ADDENDUM NO. 2 TO PROJECT NO. 43707

**ELEVATOR, ELECTRICAL & PLUMBING WORK
PROVIDE STAGE & DRESSER LIFT
GNARESP THE EGG
EMPIRE STATE PLAZA
ALBANY, NEW YORK**

October 31, 2013

LEVEL P-1 PART FLOOR PLAN - SWITCHBOARD ROOM - AND DETAILS
REF. SHEET: E-101
SHEET # SKE-002

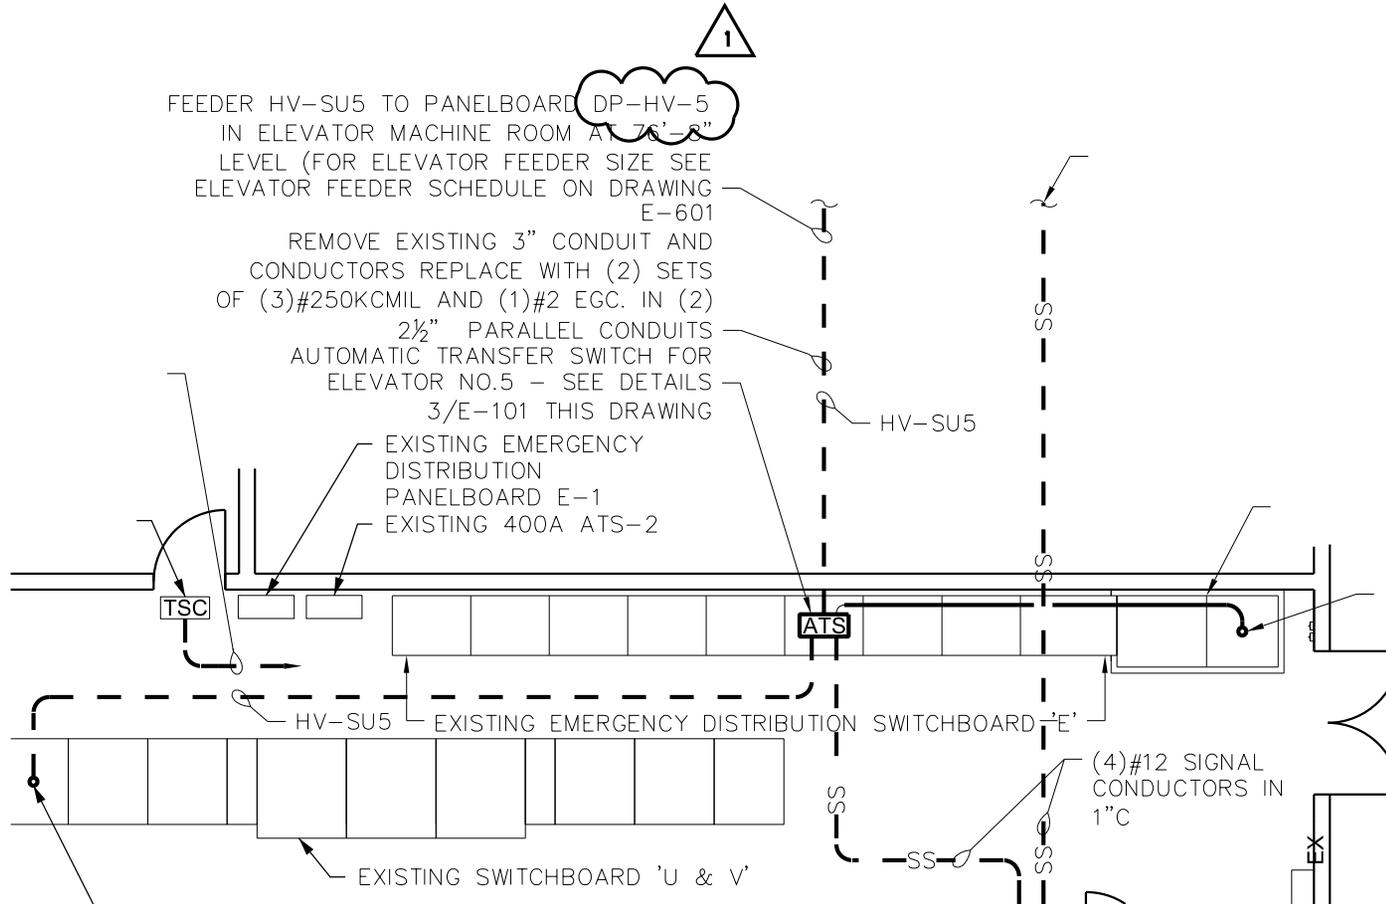
32. Drawing No. E-101:
 - a. Detail 1: Revise source of feeder HV-SU5 to DP-HV-5 in lieu of DP-HW-5. Refer to sketch SKE-002 (attached).
33. Drawing No. E-102:

PART FLOOR PLAN 103'-9" P1 LEVEL ELEVATOR PIT LIGHTING
 REF. SHEET: E-102
 SHEET # **SKE-003**

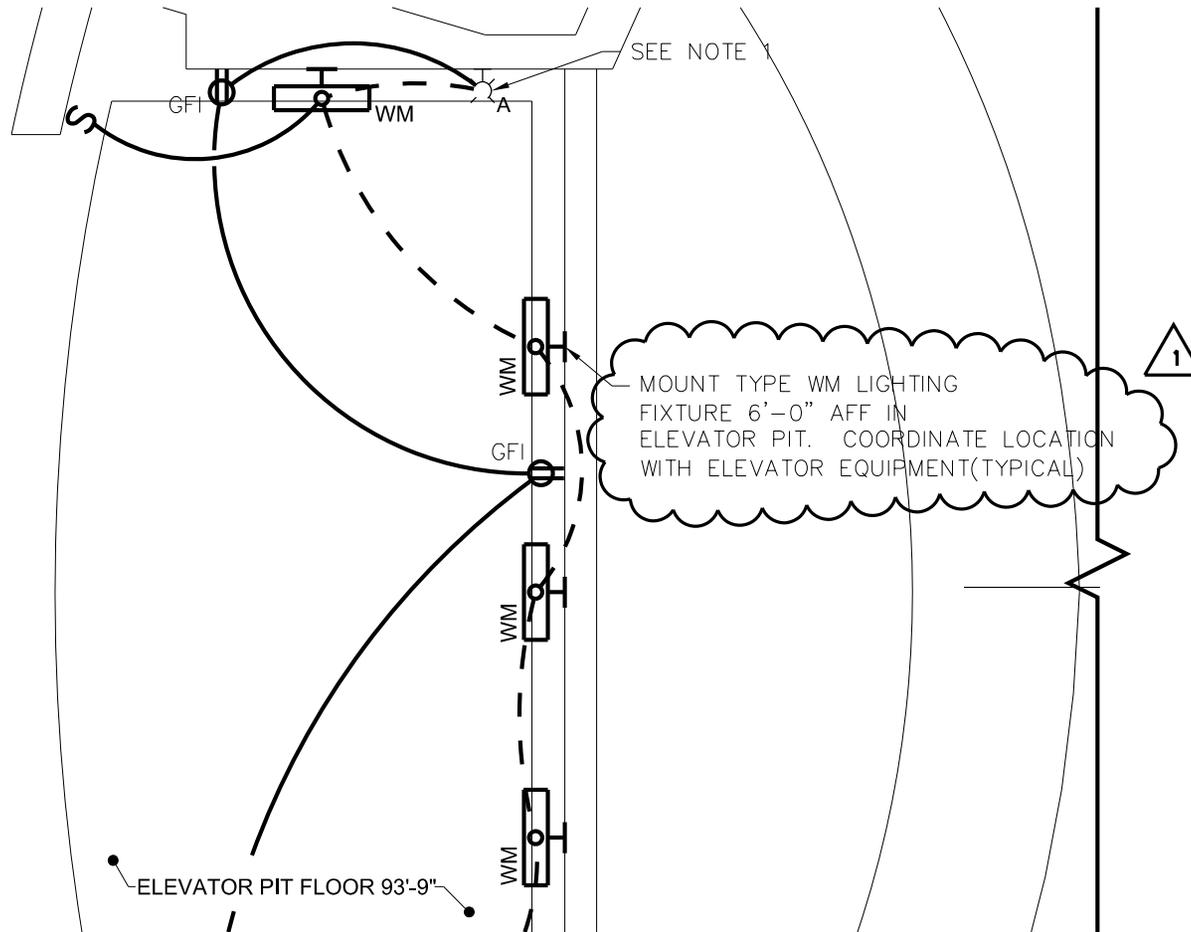
- a. Part Floor Plan 103'-9" P1 Level Elevator Pit Lighting: Revise installation note for fixture type WM. Refer to sketch SKE-003 (attached).
34. Drawing E-601:

**POWER ONE LINE DIAGRAM
- SWITCHBOARDS 'U', 'V' &
EMERGENCY BOARD
REF. SHEET: E-601**

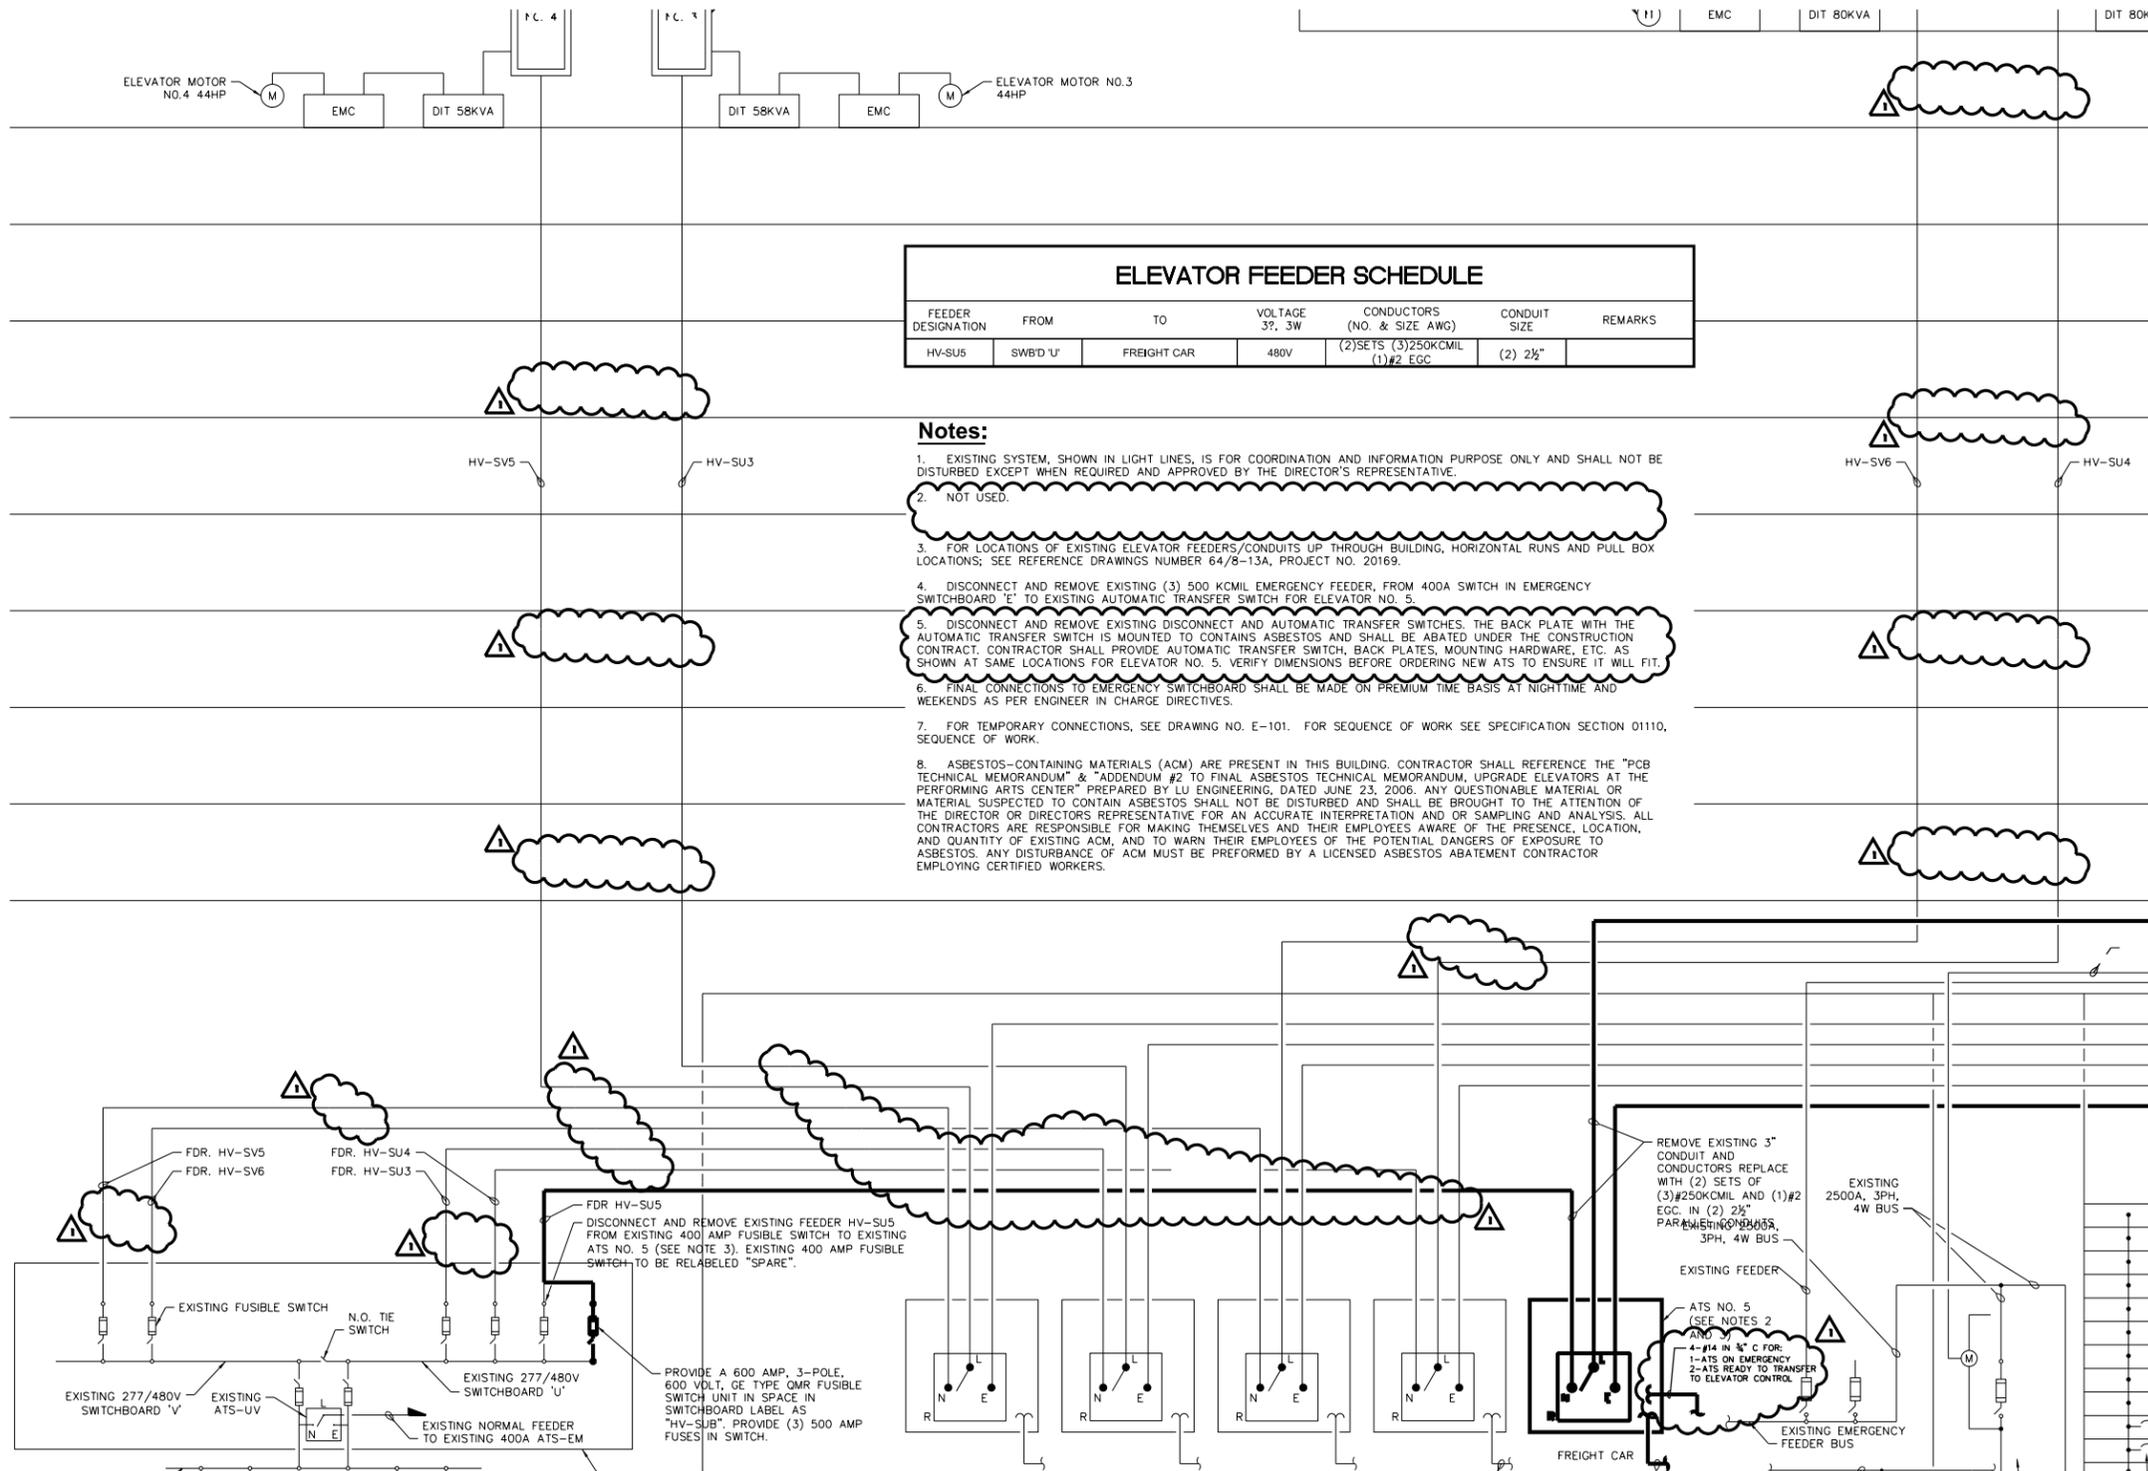
- a. Power One Line Riser Diagram - Switchboards 'U','V' & Emergency Board: Revise scope to eliminate work for Elevators 1, 2, 3, & 4. Refer to sketch SKE-004 (attached).

Addendum 2
SHEET #
SKE-005

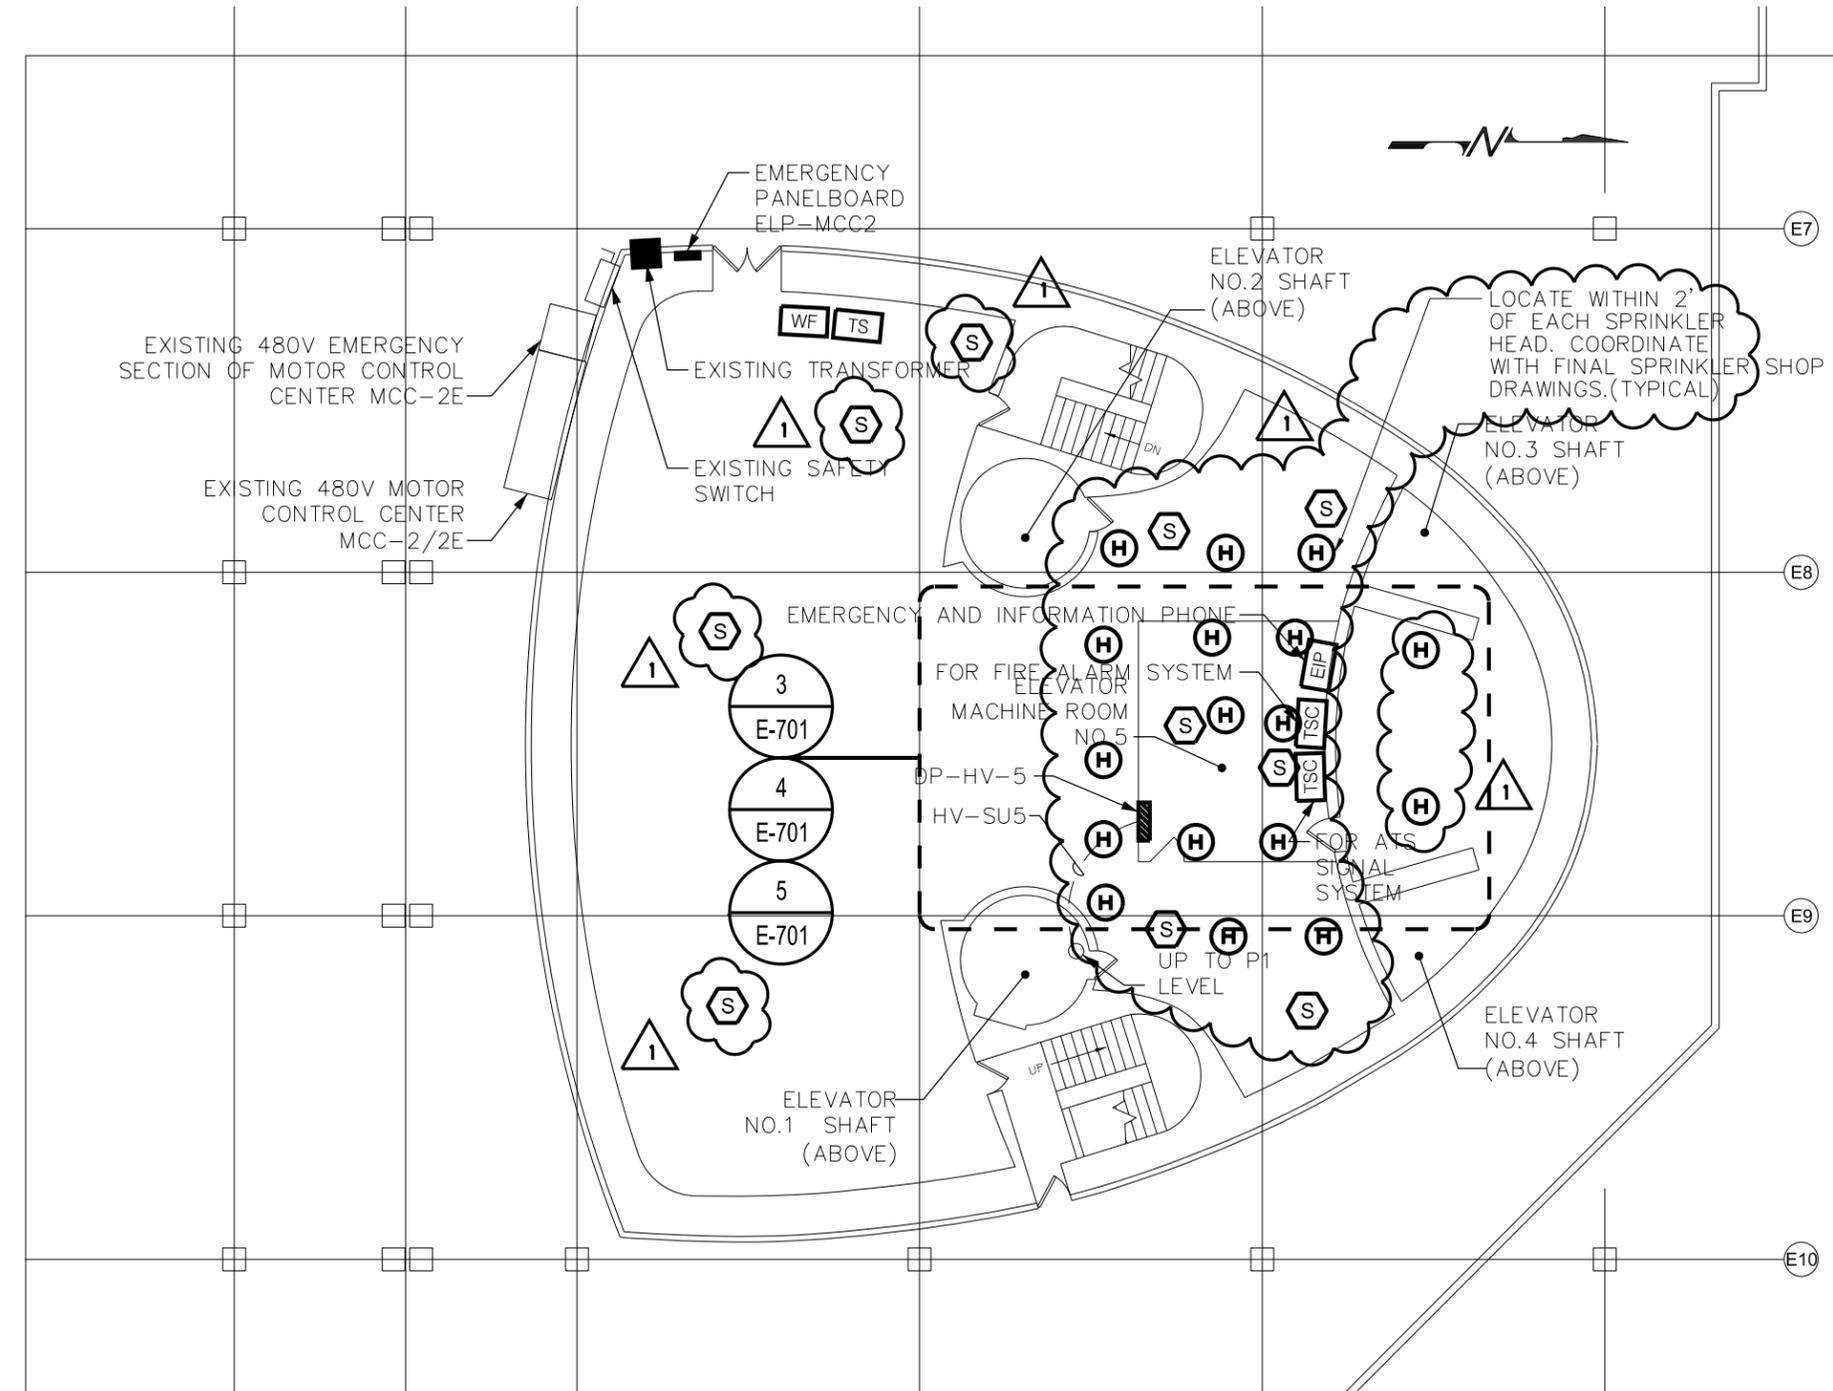
35. Drawing E-701:
 - a. Detail 1: Revise fire alarm work. Refer to sketch SKE-005 (attached).
 - b. Detail 4: Revise fire alarm work. Refer to sketch SKE-005 (attached).

- c. Detail 5: Revise to include circuiting for receptacles. Refer to sketch SKE-006 (attached).
 - d. Detail 5: Revise fire alarm work. Refer to sketch SKE-005 (attached).
